FINAL ENVIRONMENTAL IMPACT REPORT

**VILLA SERENA SPECIFIC PLAN PROJECT
UPLAND, CALIFORNIA**

April 2025

COVER SHEET

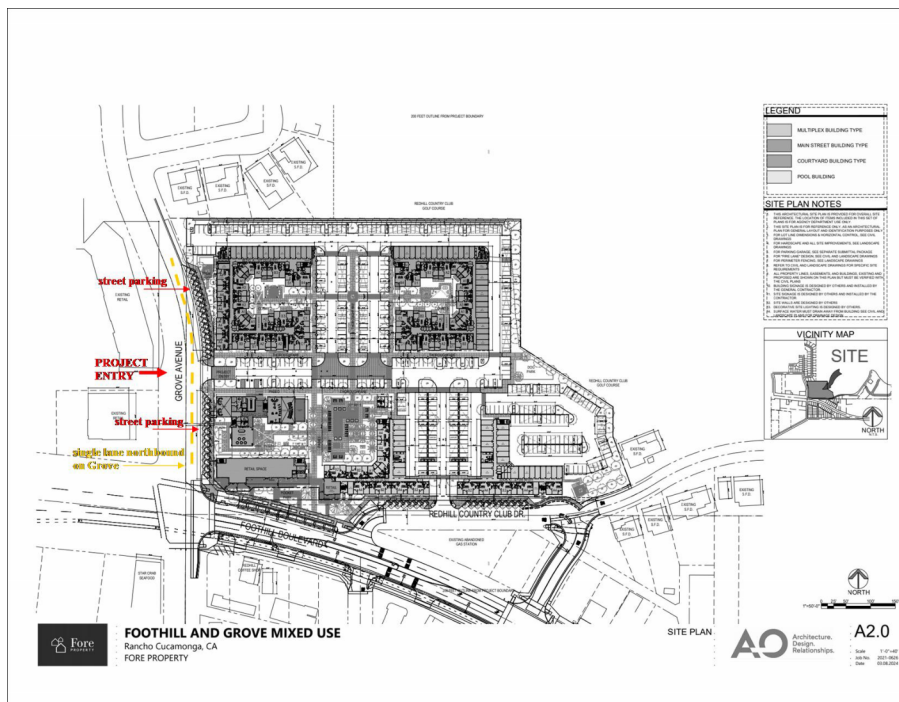
As you can see Rancho is already setting grounds in the construction of Foothill and Grove to accommodate the influx of traffic for this project. Please note, on this rendering, the vehicles parked on public streets (on Grove, back-in only) are positioned to go north. These are parking areas for the commercial renters. It would be a difficult maneuver to exit south on Grove because the Walmart shopping center also has an exit and southbound gets backed up. May I remind the Planning Commission, this is Rancho's project not Upland. According to their study regarding this development, it will increase traffic by approximately 700 vehicles. Together with Villa Serena's 632, this will impact this area negatively and affect the quality of life for our neighborhood and the City of Upland.

It appears to have an Exit/Entry point on Grove Ave. into the new development. If so, how is acceptable since this is a City of Rancho project and Grove is in Upland? (Error correction on map in yellow, please ignore.)

The commenter cites specific concerns regarding development in Rancho Cucamonga that is planned at the northeast corner of Foothill Boulevard and Grove Avenue. Notably, the commenter cites that the combined traffic from the proposed project and the project in Rancho Cucamonga would negatively impact their neighborhood and Upland.

As noted by the commenter, Rancho Cucamonga is the Lead Agency tasked with evaluating the direct, indirect, and cumulative impacts of development within its jurisdiction. As such, the traffic impacts referenced by the commenter would be properly evaluated by the City of Rancho Cucamonga. The City of Upland did not require the intersection of Foothill Boulevard and Grove Avenue to be addressed in the project-specific traffic study, because the proposed project would not contribute 50 or more peak hour trips at that intersection. The Traffic Impact Analysis

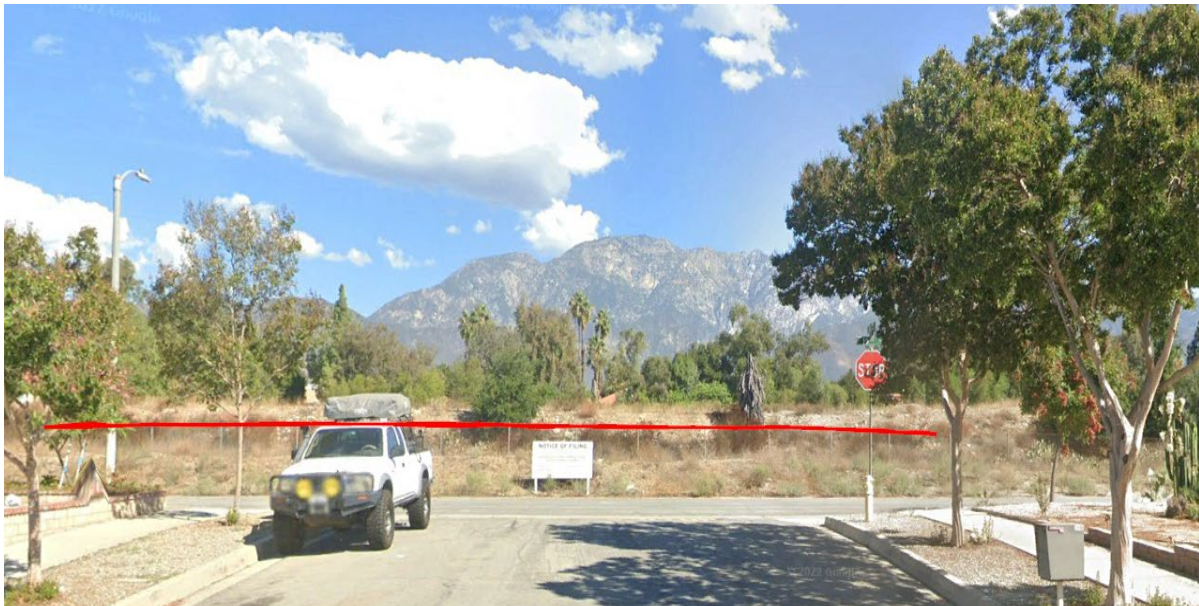
Current views north from Fernando Avenue to the project site are provided in the photograph below. As shown, the proposed project site is visible in the foreground with the San Gabriel Mountains offering background views. Under the current condition, golf course landscaping partially blocks views of the lower slopes of the San Gabriel Mountains.

Post-development, views north to the San Gabriel Mountains will include the proposed two-story homes, enhanced streetscape, and project landscaping in the foreground (see simulation on the next page). As shown, the height of the proposed two-story residences is approximate to the height of the existing current golf course landscaping that blocks views of the lower slopes of the San Gabriel Mountains. Views of the prominent ridgelines of the mountains are maintained.

FIGURE 3.1

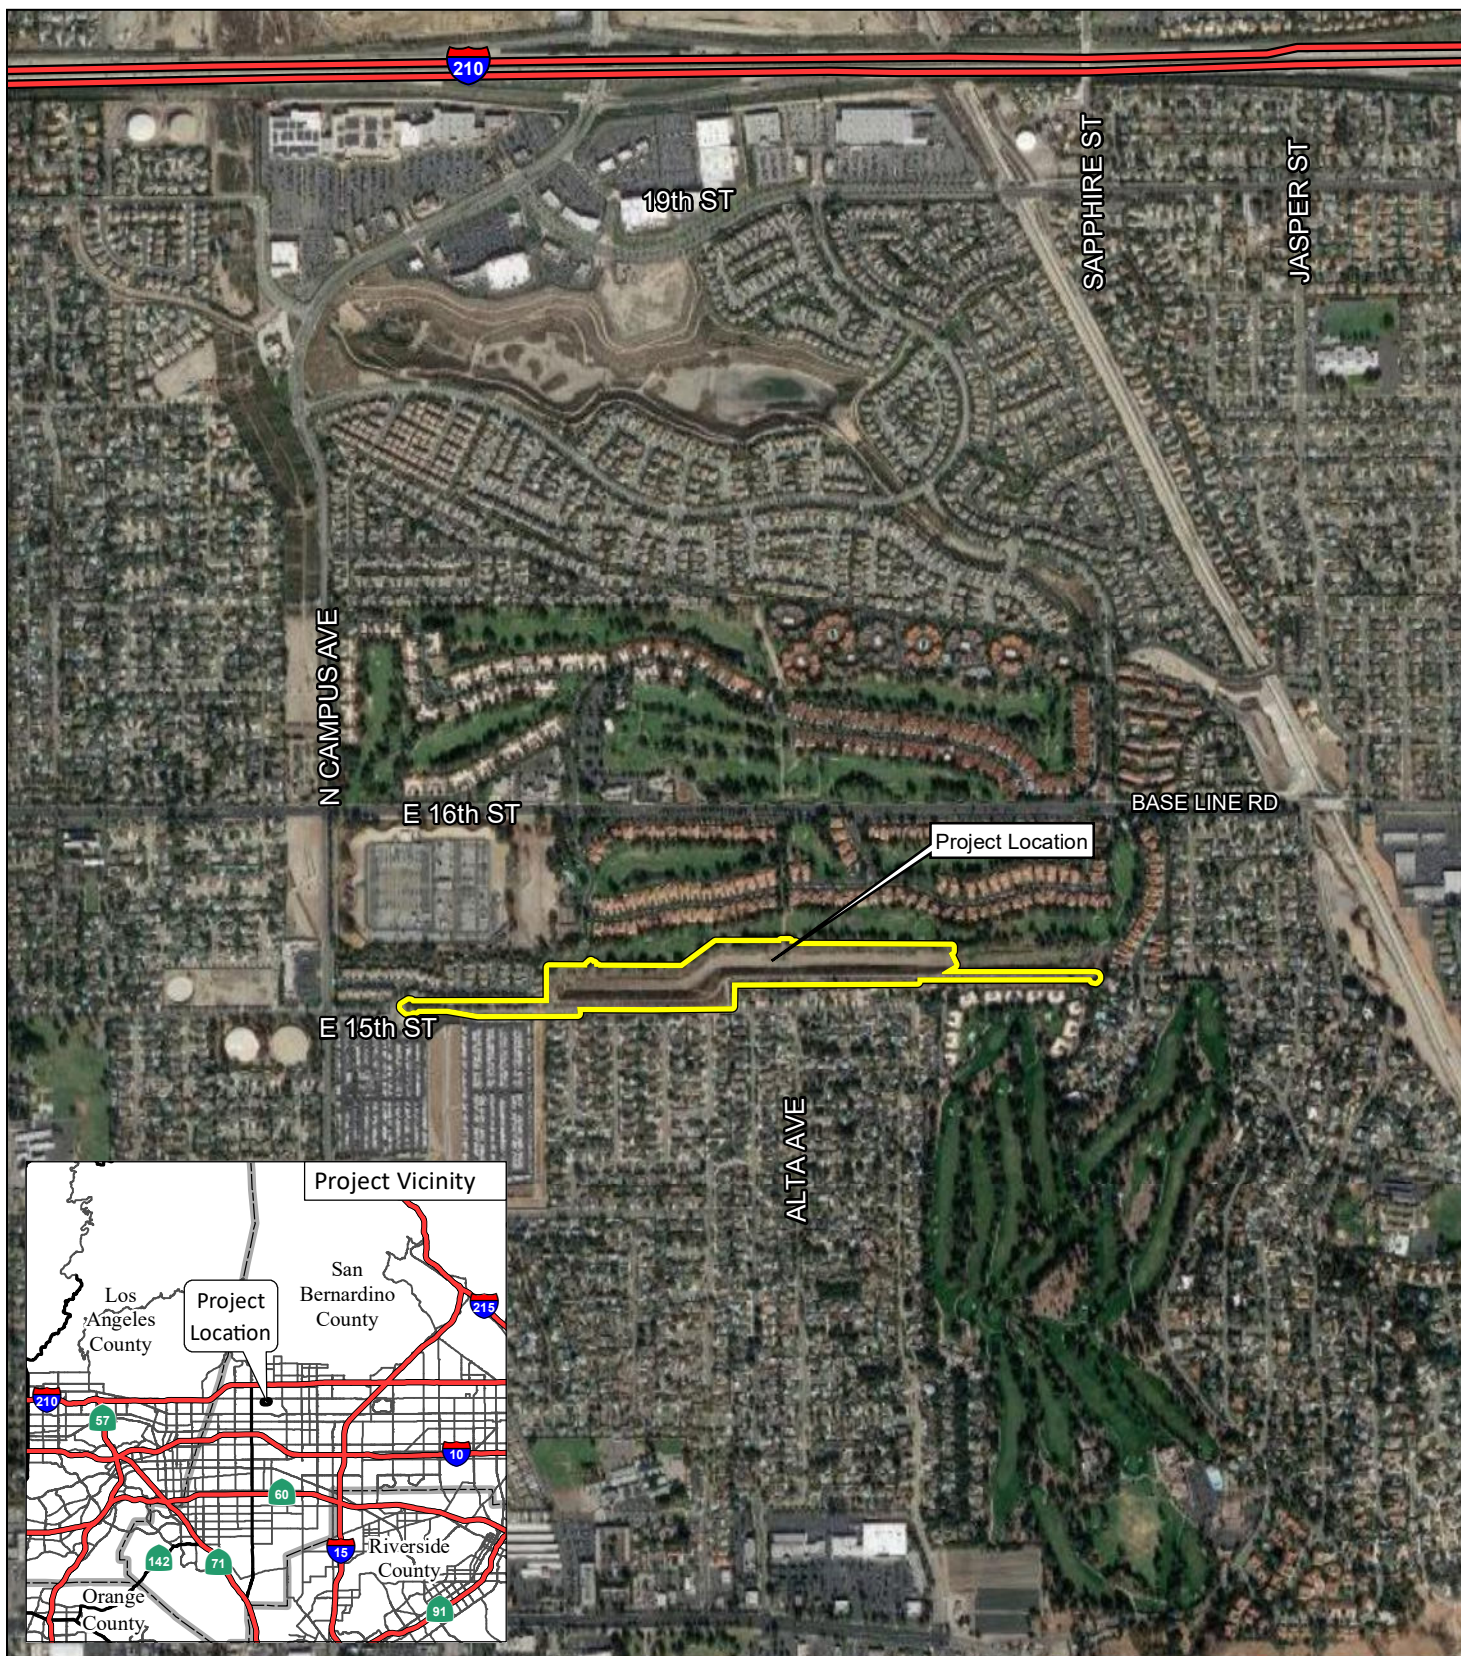
Chapter 3.0 Project Description, page 3.3, Figure 3-1

Page 3.3, Figure 3-1, revised the figure to reflect the proper name of Alta Avenue (see revised figure).
